UNITED STATES PATENT AND TRADEMARK OFFICE

APPLICATION NO.	FILING DATE	FIRST NAMED INVENTOR	ATTORNEY DOCKET NO.	CONFIRMATION NO.
10/661,116	09/12/2003	Martin A. Putnam	CV-0044	6433

Office Action Summary	Application No.	Applicant(s)	
	10/661,116	PUTNAM ET AL.	
	Examiner	Art Unit	
	Arnel C. Lavarias	2872

DETAILED ACTION

FIG. 27

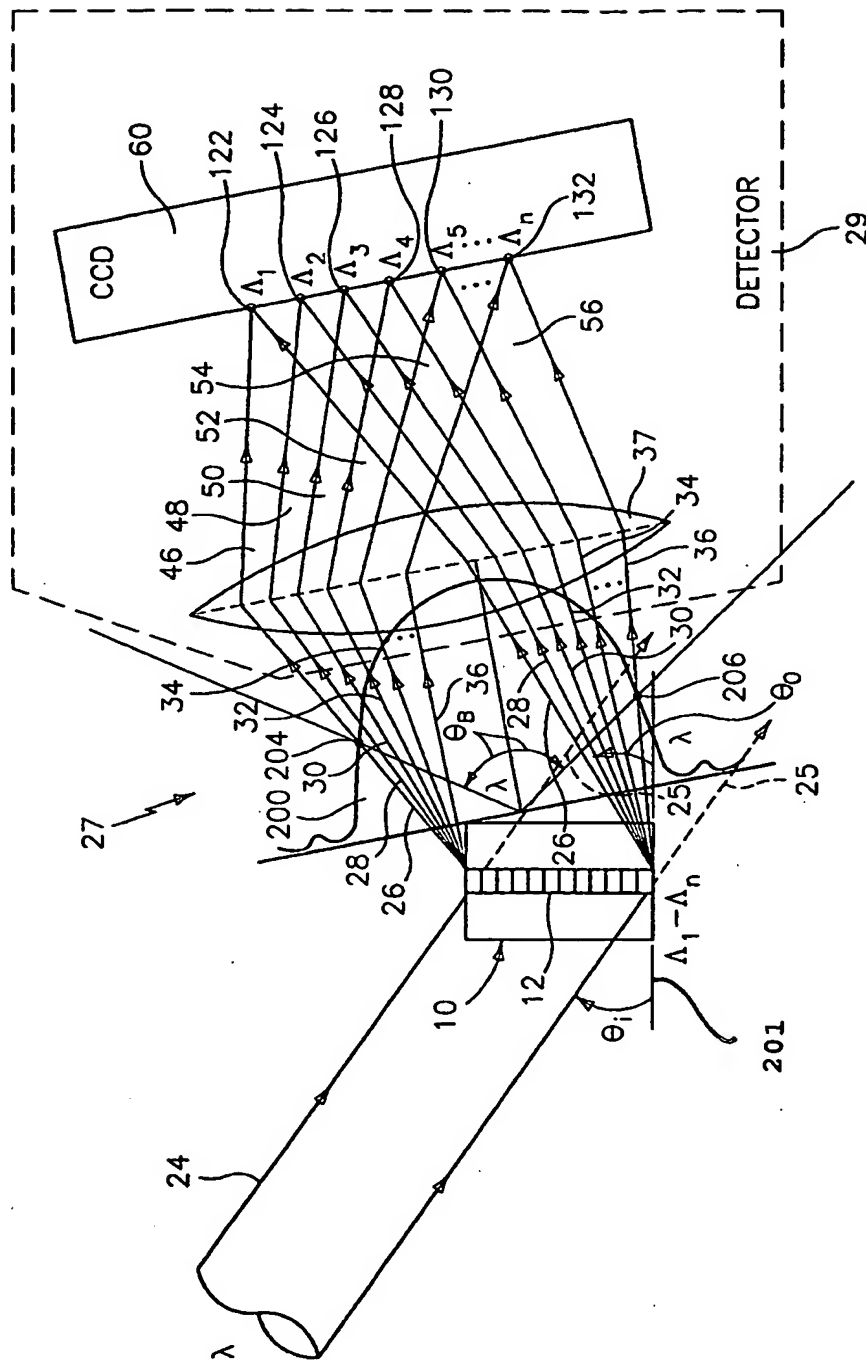
2. The drawings were received on 2/16/05. These drawings are objected to for the following reason(s) as set forth below.
3. The drawings are objected to as failing to comply with 37 CFR 1.84(p)(5) because they do not include the following reference sign(s) mentioned in the description:

Figure 27- Reference numeral 203 (See Page 19, lines 12 and 14).

Corrected drawing sheets in compliance with 37 CFR 1.121(d) are required in reply to the Office action to avoid abandonment of the application. Any amended replacement drawing sheet should include all of the figures appearing on the immediate prior version of the sheet, even if only one figure is being amended. Each drawing sheet submitted after the filing date of an application must be labeled in the top margin as either "Replacement Sheet" or "New Sheet" pursuant to 37 CFR 1.121(d). If the changes are not accepted by the examiner, the applicant will be notified and informed of any required corrective action in the next Office action. The objection to the drawings will not be held in abeyance.
